# Access Compliance Report

## Public Rights-of-Way

Intersection ID: 19640	Main Street: MONROE_RD	Cross Street: VILLAGE_LAKE_DR	Location: NE
ADA ID: A73F1F05E873	Ramp Type: PerpDiag	Initial Pass/Fail: Fail	Overall Compliance: No
Severity Score: 13.75			
Codes/Mitigation Info/Possible Solution		Field Measurements/Component Compliance

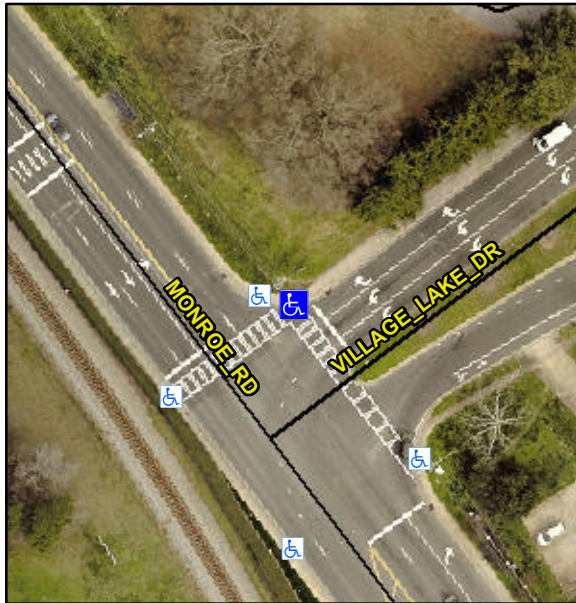
**R304.2.2, R304.5.3**

Compliance	Description	Data	Compliance	Description	Data
N/A	Ramp Length (in)	60.0	No	Ramp Slope (%)	9.4
Yes	Ramp Width (in)	55.0	No	Ramp XSlope (%)	3.5
N/A	Flare Type LT	N/A	N/A	Flare Type RT	N/A
N/A	Flare Slope LT (%)	N/A	N/A	Flare Slope RT (%)	N/A
N/A	Flare Traversable LT?	N/A	N/A	Flare Traversable RT?	N/A
N/A	Landing Length (in)	N/A	N/A	DWS Provided?	N/A
N/A	Landing Width (in)	N/A	N/A	DWS Contrast?	N/A
N/A	Landing Slope (%)	N/A	N/A	DWS Length (in)	N/A
N/A	Landing X Slope (%)	N/A	N/A	DWS Full Width?	N/A
N/A	Landing Curb? (Y/N)	N/A	N/A	DWS Offset (in)	N/A
N/A	Shared Landing?	N/A			
N/A	Gutter Ponding?	N/A	N/A	Gutter Slope (%)	N/A
N/A	Gutter Lip Ht (in)	N/A	N/A	Gutter X Slope (%)	N/A
N/A	Painted X Walk1?	Yes	N/A	Painted X Walk2?	Yes
	X Walk 1 Direction	To SW		X Walk 2 Direction	To SE
N/A	X Walk 1 Width (in)	117.0	N/A	X Walk 2 Width (in)	113.0
	X Walk 1 Slope (%)	1.2		X Walk 2 Slope (%)	1.5
	X Walk 1 X Slope (%)	0.1		X Walk 2 X Slope (%)	1.9

N/A	Ramp inside XWalk1?	Yes	N/A	Ramp inside XWalk2?	Yes
	Road Slope (%)	1.1	N/A	Clear Space?	N/A
	Road X Slope (%)	2.1	N/A	Clear Space to XWalk (in)	N/A
N/A	Any Obstructions?	N/A	N/A	Storm Grate/Utility Hazard?	N/A
	Obstruction Type			Storm Grate/Utility Type	
		N/A			N/A
		Yes		Surface Condition? (G/P)	Good

**Remove & Replace Curb Ramp With Two New Directional Ramps or Equivalent.**
